Economic Commission for Europe**Inland Transport Committee****World Forum for Harmonization of Vehicle Regulations****Working Party on Lighting and Light-Signalling****Seventy-ninth session**

Other Regulations:**Regulation No. 50 (Position, stop, direction indicator lamps for mopeds and motorcycles)****Proposal for a new Supplement to the 01 series of amendments to Regulation No. 50****Submitted by the expert from the International Motorcycle Manufacturers Association (IMMA)*,****

The text reproduced below was prepared by the expert from IMMA with the aim to propose amendments to Regulation No. 50 regarding inward geometric visibility requirements for rear position lamps. The modifications to the existing text of the Regulation No. 50 are marked in bold for new or strikethrough for deleted characters.

2.2. Rear position lamps (for a pair of lamps)

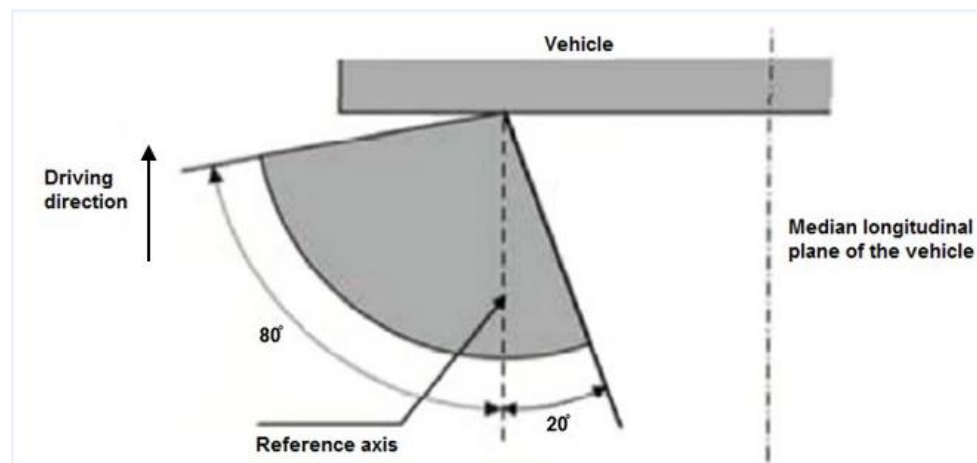
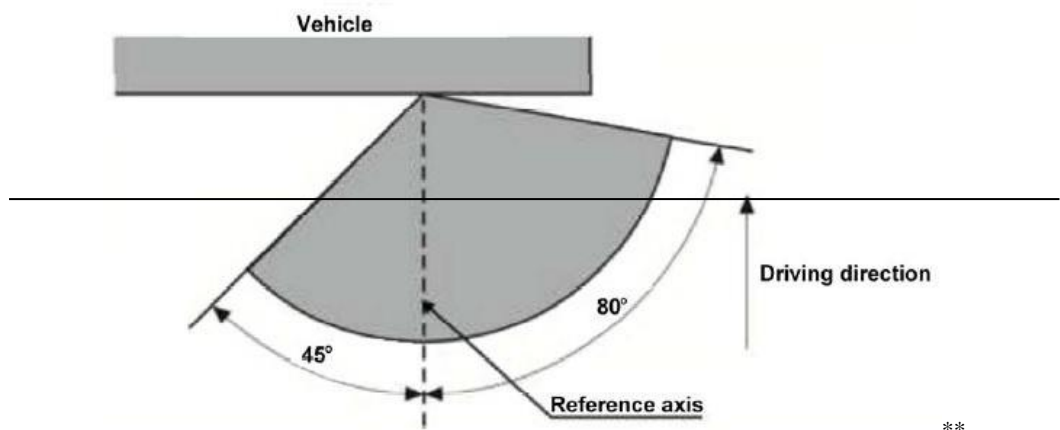
~~However, in the case where a device is intended to be installed with its H plane at a mounting height less than 750 mm above the ground, the inward angle of 45° may be reduced to 20° under the H plane."~~

** Picture deleted.

2.2.1. $V = +15^\circ / -10^\circ$

2.2.2. However, in the case where a device is intended to be installed with its H plane at a mounting height less than 750 mm above the ground, the angle of 10° below the horizontal may be reduced to 5° .

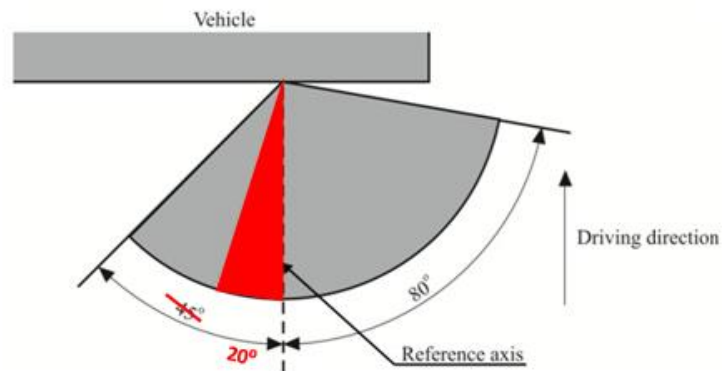
1. This proposal aims to align the angle of visibility requirements of rear position lamps with the angle of visibility requirements of front position lamps, leading to the following:

- (a) Inward angle (or the angle towards the median longitudinal plane of the vehicle) of 20° (and not of 45°); see the above angles in red.
 - (b) Last sentence of paragraph 2 shall be deleted.
2. The last picture could be changed as follows:

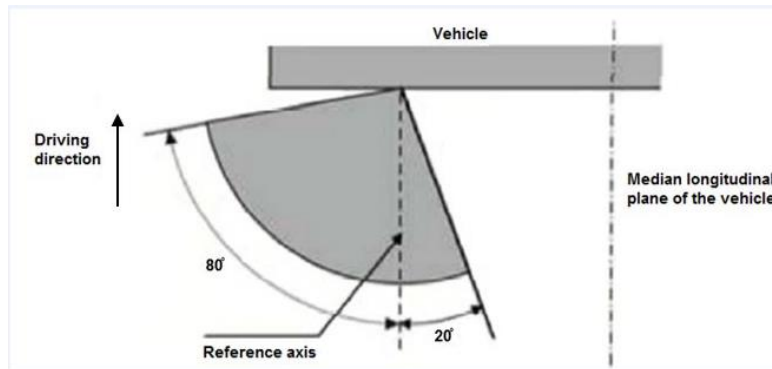
or, symmetrically, as follows:
